• FINAL PLAT OF •
• **STONEHEDGE SECOND ADDITION** •
• **AN ADDITION TO WICHITA, SEDGWICK COUNTY, KANSAS** •

Re.: S/D 84-113 - Final Plat of Stonehedge 2nd Addition

Final Plat
SUBDIVISION REPORT
S/D 84-II3 - STONEHEDGE 2ND ADDITION

S/D No.: 84-113 Name: STONEHEDGE 2ND ADDITION

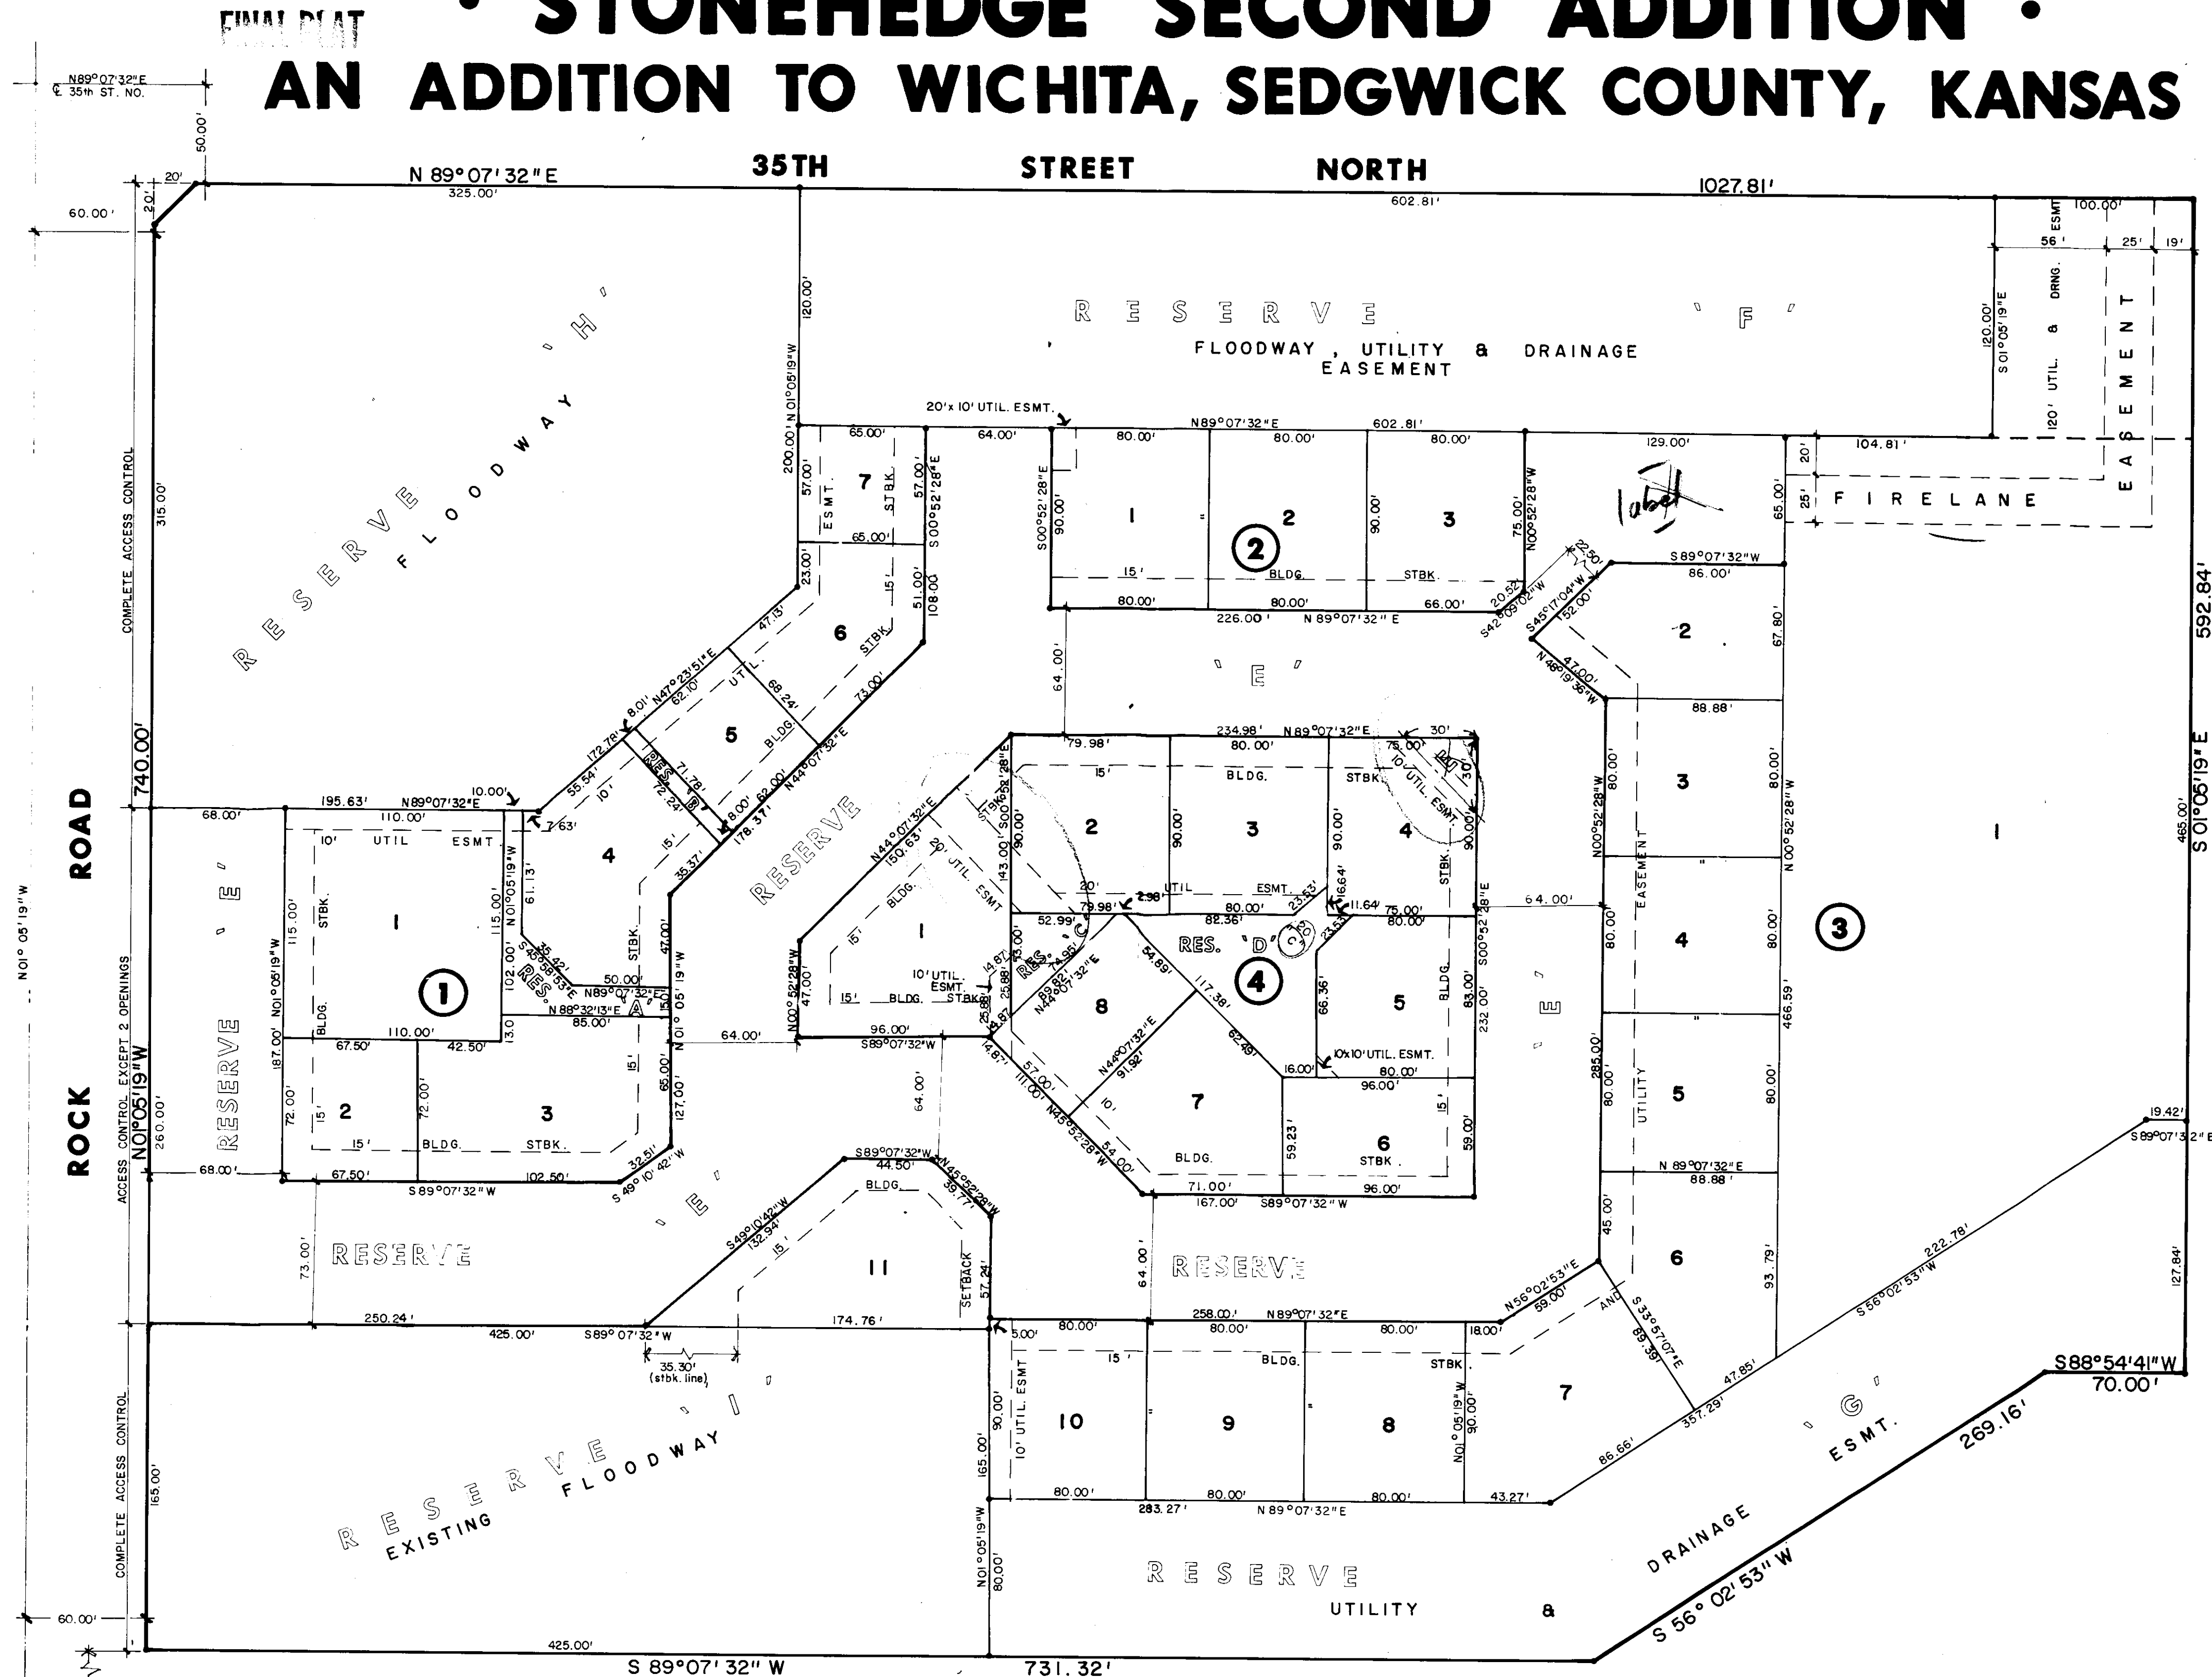
- L. On the final plat tracing, the center line of the 10-foot utility easement at the northeast corner of Lot 4, Block 4 shall be labeled.
- M. On the final plat tracing, the 20-foot utility easement, at the northeast corner of Lot 1, Block 4 and the southwest corner of Lot 2, Block 4, shall be dimensioned from lot lines.

- N. On the final plat tracing, ED RESA shall be indicated as Deputy to the Register of Deeds.
- O. On the final plat tracing, the signature block of the County Commissioners shall be corrected to reference the following order of signatures:

- 1. DONALD E. GRAGG
 - 2. BERNARD A. HENTZEN
 - 3. TOM SCOTT
- P. On the final plat tracing, the platlor's text shall be amended to reference the platting of Reserve "B."

- Q. On the final plat tracing, the area north of Lot 2, Block 3 and east of Lot 3, Block 2 shall be labeled.
- R. Closure computations shall be submitted with the final plat tracing.

- U. The applicant, or his agent, shall be prepared to state what the 20 "C" labeling within Reserve "D" means.
- V. The applicant, or his agent, shall be prepared to state what the "E" labeling within Lot 4, Block 4 means. Is this now part of Reserve "E"? If so, why haven't the lot lines been adjusted for Lot 4, Block 4?

- F. As required at the time of preliminary plat approval, this plat shall indicate the boundaries and recording data of the private sewer easement which provides Lot 2, Block 1 with sanitary sewer service. This private easement shall be indicated on the final plat tracing.

- G. On the final plat tracing, the labeling of the utility and drainage easement, adjacent to the north line of Lot 1, Block 3, shall be accompanied by arrows which indicate the boundaries of this easement (i.e., is the easement's east line the west line of the firelane easement or is it the east line of the plat?).

- H. The final plat tracing shall clarify the conflict between the plat's text and the face of the plat regarding the purposes of Reserve "F" (i.e., is this Reserve being platted for floodway purposes or not?).

- I. The required minimum building pad shall be expressed in Mean Sea Level as well as in City Datum.
 - J. Access to all interior lots in Blocks 1 through 3 is to be provided in Reserve "A." The applicant is advised that, at the time of lot development, improvements in Reserve "A" will be required to meet the minimum firelane standard.
